HORSHAM DISTRICT COUNCIL CONSULTATION

TO:	Horsham District Council – Planning Dept
LOCATION:	Land To The South of Broadbridge Way Broadbridge Heath West Sussex (Wickhurst green)
DESCRIPTION:	Full Planning Application for the erection of 89no. residential dwellings comprising dwellings (54no.) and apartments (35no.), 36% affordable homes, creation of new vehicular access on to Sergent Way, provision of public open space, landscaping and drainage solutions
REFERENCE:	DC/25/0894
RECOMMENDATION:	Modification

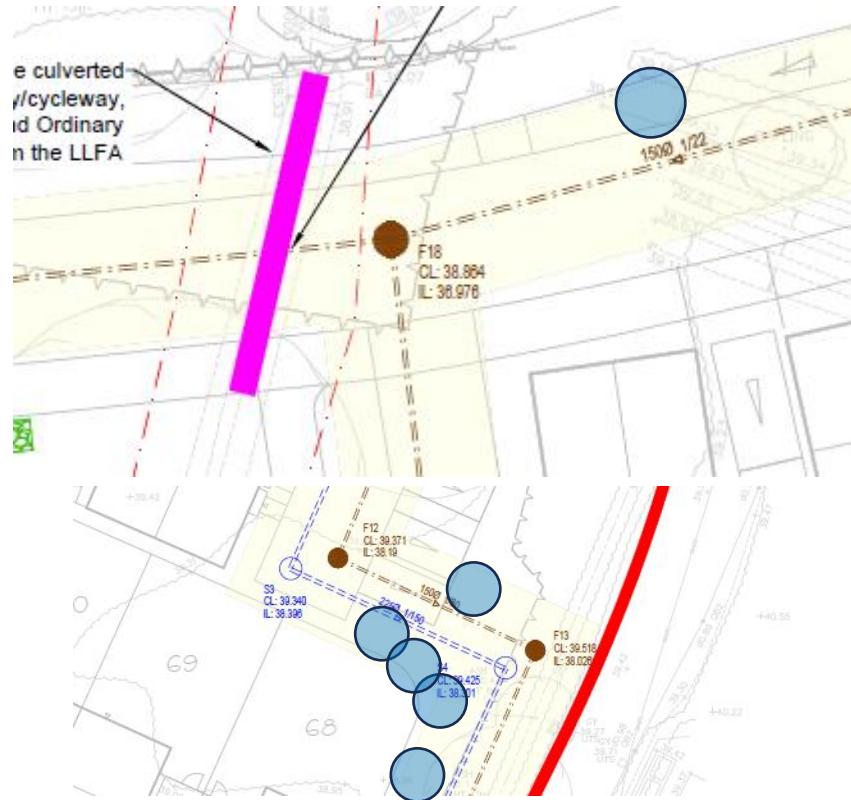
12. The SuDS proposals do not meet the full design criteria listed under 6.7.1 within the FRDR, with Amenity and Biodiversity notably missing from the proposed solutions.

We note from the 'Technical Note Surface Water Drainage: Response to LLFA Comments' that, 'It has not been possible to provide SuDS across the site in order to intercept the first 5mm of rainfall for the majority of rainfall events due to development specific constraints'. We do not concur with this statement and consider that there are further opportunities for SuDS that can be delivered on site, that also address the unmet design criteria of Amenity and Biodiversity. For example:

- a. Rain gardens, as noted under point 6
- b. Introducing blue green roofs to ancillary structures such as bin and cycle stores, which would be highly effective given their combined water collection area
- c. Wetland planting within the Open Space and/or alongside the stream and riparian buffer
